**PLANNING BOARD AGENDA**  
**MAY 26, 2021 – 7:00 P.M.**

RE: 102 Gleneida Ave  
Town of Carmel  
TM# ~~44.14-1-22~~  
44.14-1-22

Please find enclosed the following plans and documents in support of an application for site plan approval for the above referenced project:

**DRAWING:**  
 ALTERNATIVE PARKING PLAN

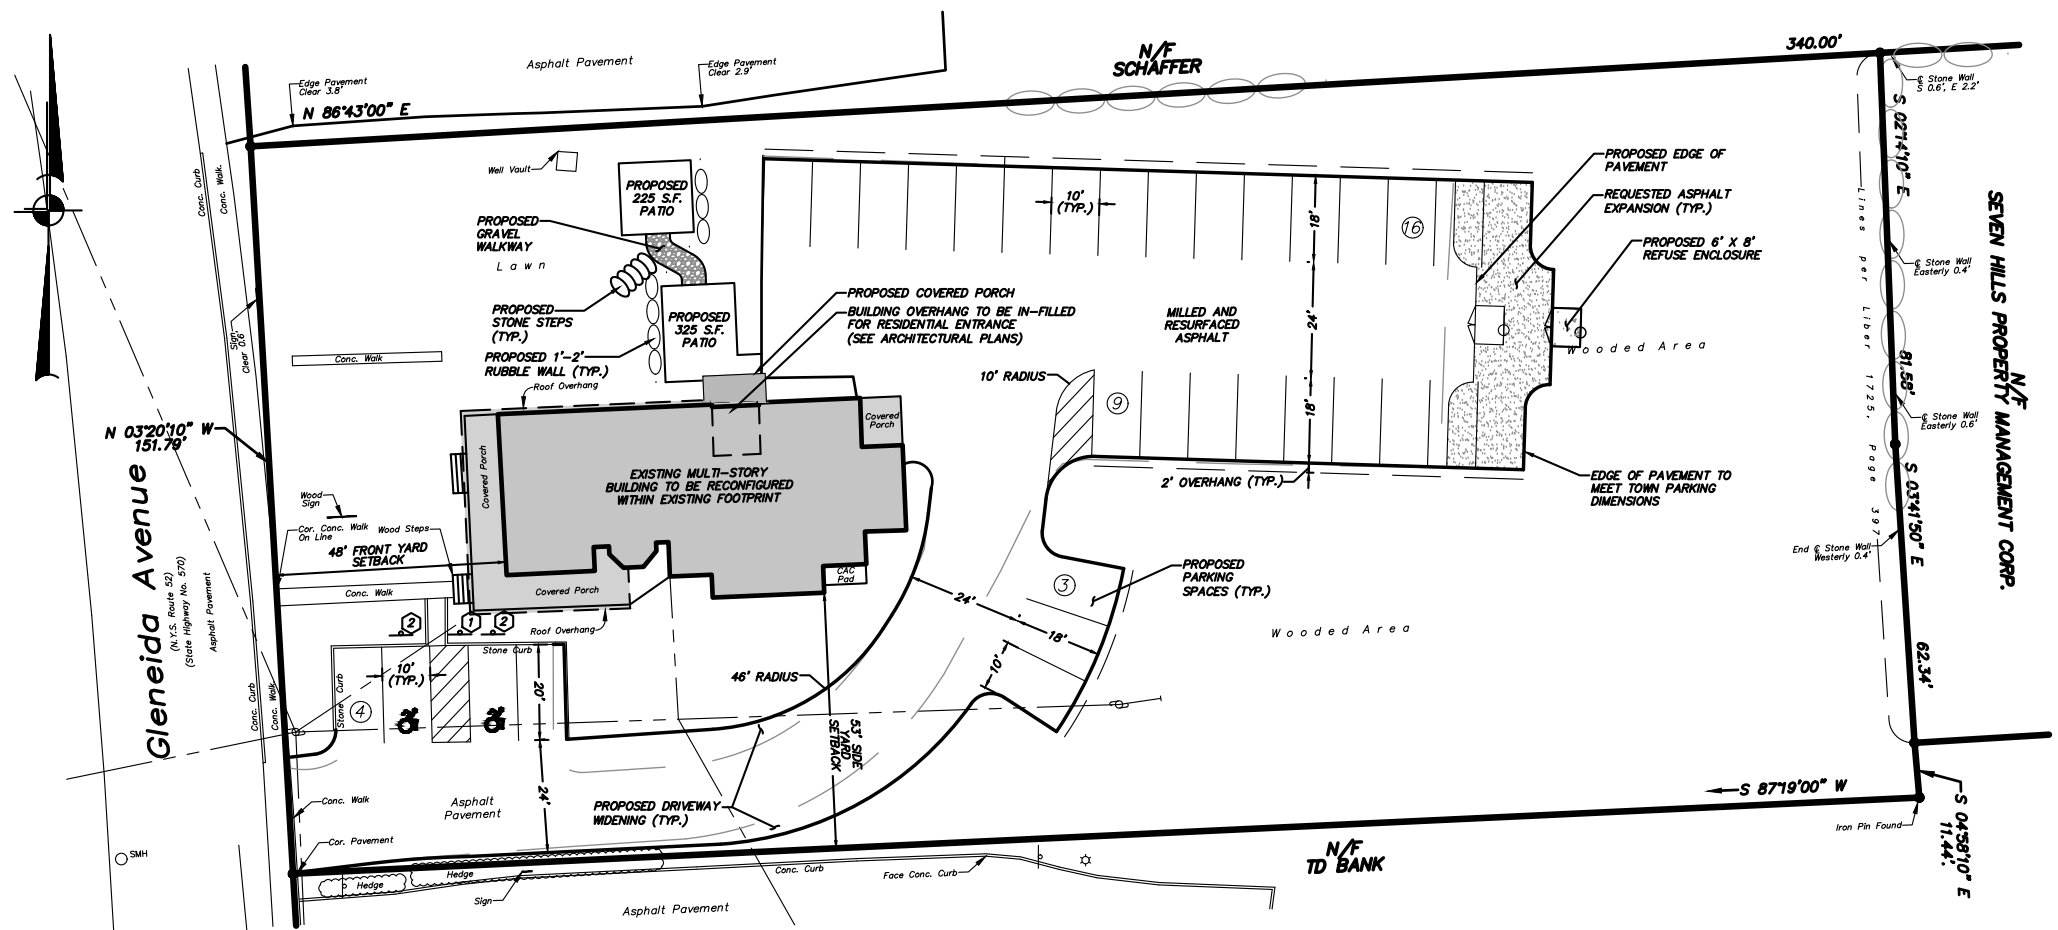
We have provided an Alternative Parking Plan, showing the additional parking area to accommodate the larger parking spaces, per the town requirements. While this alternative is feasible from a constructability standpoint, the applicant feels that it is an unnecessary burden, and less desirable in several ways including:

Alternative Plan has been provided which adds parking area to accommodate the larger spaces. See the response above regarding the applicant's stance on adding pavement to meet the Town standard for the existing parking areas.

**SITE PLAN**

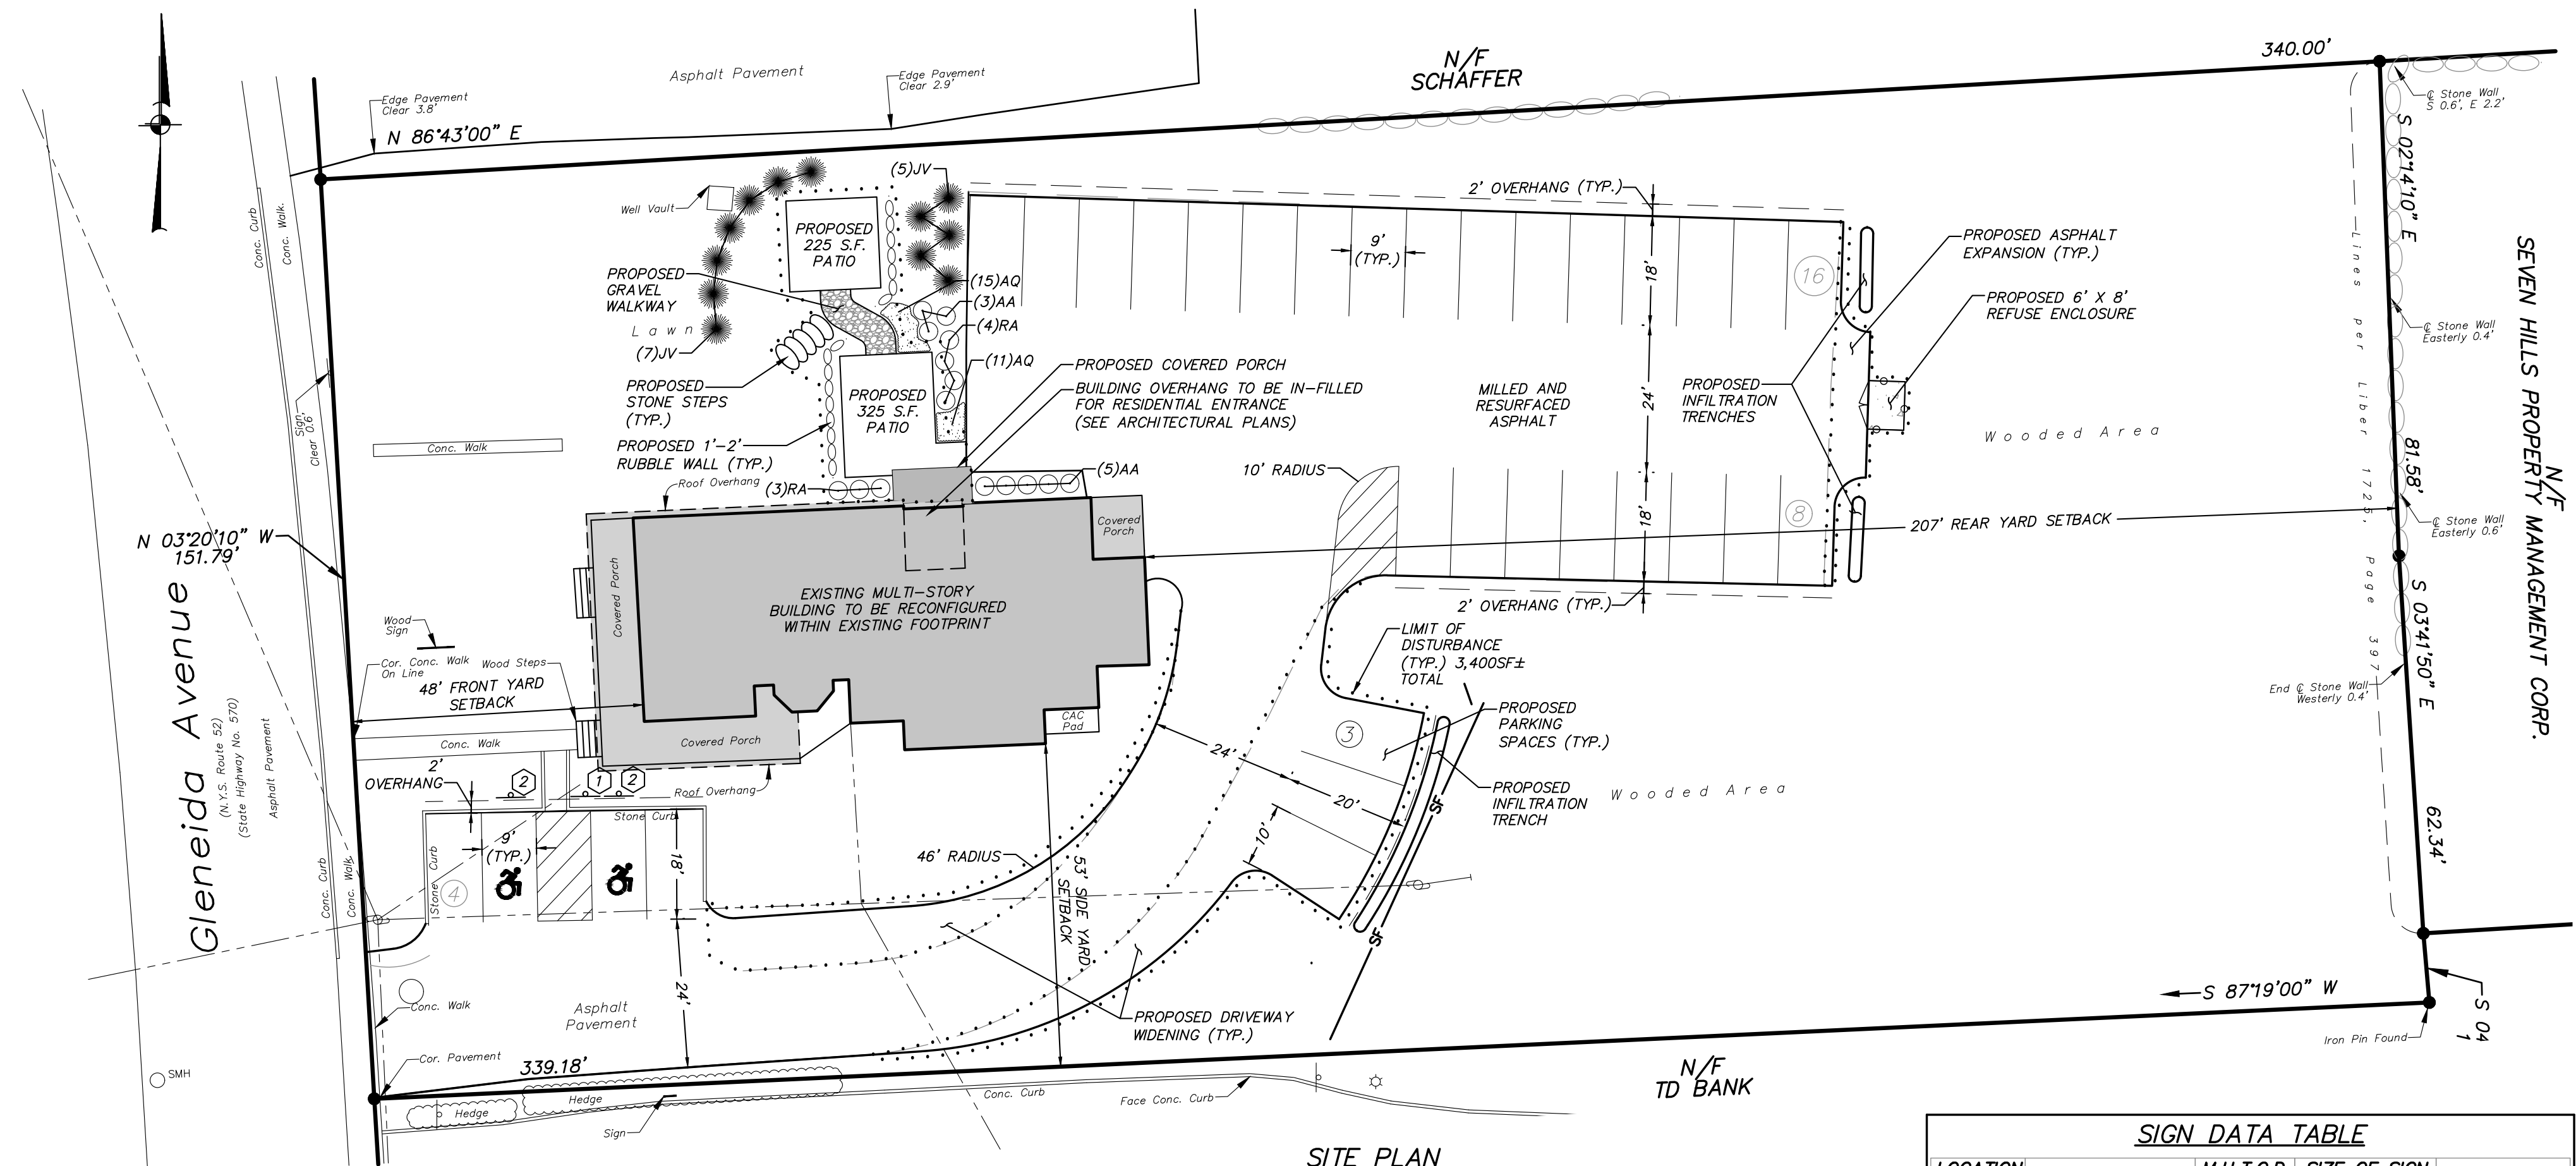
3. A Water & Sewer report has been provided.
4. A note has been added to sheet SP-1 that a all sidewalks, manholes and guiderails should be installed.
5. A note has been added to sheet SP-1 that all plantings are to be verified by the Town of Carmel Wetland Inspector.

6. A note has been added to sheet SP-1 that all plantings are to be installed per §128 of the Town of Carmel Code.
7. A Lighting Plan will be provided with a future submission. The applicant's intention is for any proposed building mounted or pole mounted lighting to be dark sky compliant, full cutoff, LED fixtures, with no light spill across the property lines.

8. A Sight Distance Figure has been added to sheet SP-1. Gleneida Avenue is relatively flat and straight in this area and the sight distances well exceed the NYSDOT prescribed minimums for 30 mile per hour roads.

MANEUVERING PLAN PASSENGER VEHICLE

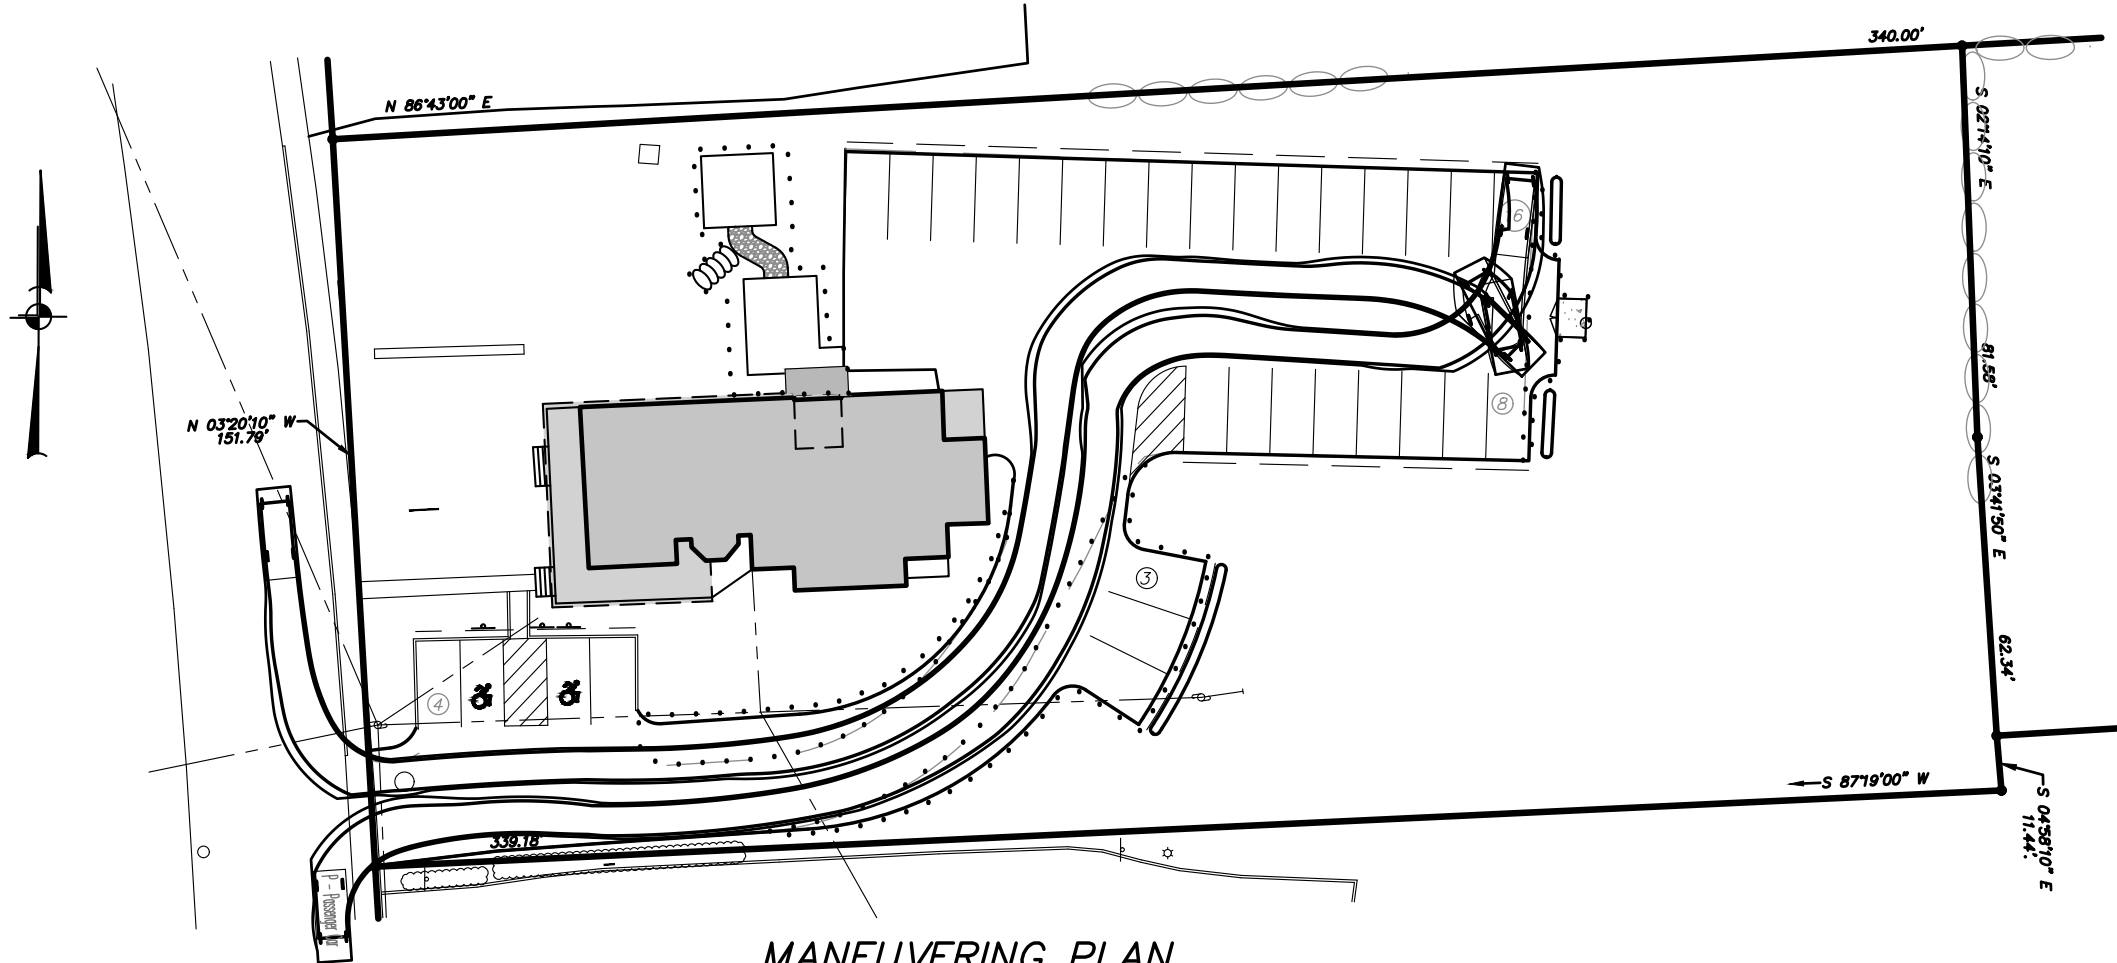
- a. Maneuvering plans have been shown on sheet SP-1 for a passenger vehicle and refuse truck.
  - b. Turning radii have been added to sheet SP-1.

- a. Putting the dumpster adjacent to the building or amenity area would be undesirable for reasons of appearance and potential odors.
  - b. As shown in the Vehicle Maneuvering Plan on sheet SP-1, it is the best place for maneuverability for the collection truck. It is this office's experience, that refuse enclosures need to be designed so that collection trucks can access dumpsters squarely. To put it anywhere else on the site would create more challenging approach for the collection vehicle.
